Access Compliance Report

Public Rights-of-Way

(Pedestrian Signals)

Intersection ID: N/A	Main Street:	Cross Street: N/A	Location: N/A
ADA ID: 8802A92BF9C0	Signal Type: Two Push Buttons-Non APS	Overall Compliance: No	Severity Score: BTN 1:N/A BTN 2: N/A No BTN: N/A
Codes/Mitigation Info/Possible Solution		Field Measurements/Component Compliance

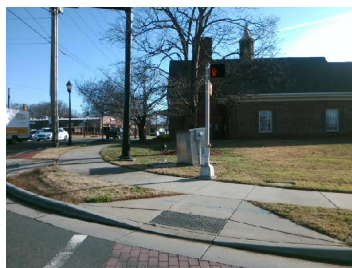
PROW/ADA: TMUTCD 4e.08, R404.2, R404.3, R404.7.2

N/A	B 1 Clear Xing Direction?	Yes	N/A	B 2 Clear Xing Direction?	Yes
	B 1 Crossing Direction	To NW		B 2 Crossing Direction	To SW
No	B 1 DistanceTo XWalk (in)	84.0	Yes	B 2 DistanceTo XWalk (in)	4.0
No	B 1 DistanceTo Curb (in)	150.0	No	B 2 DistanceTo Curb (in)	150.0
Yes	B 1 Diameter (in)	2.0	Yes	B 2 Diameter (in)	2.0

Possible Solutions: Replace Signal Push Button With APS Button on New Post. Remove & Relocate Sign.
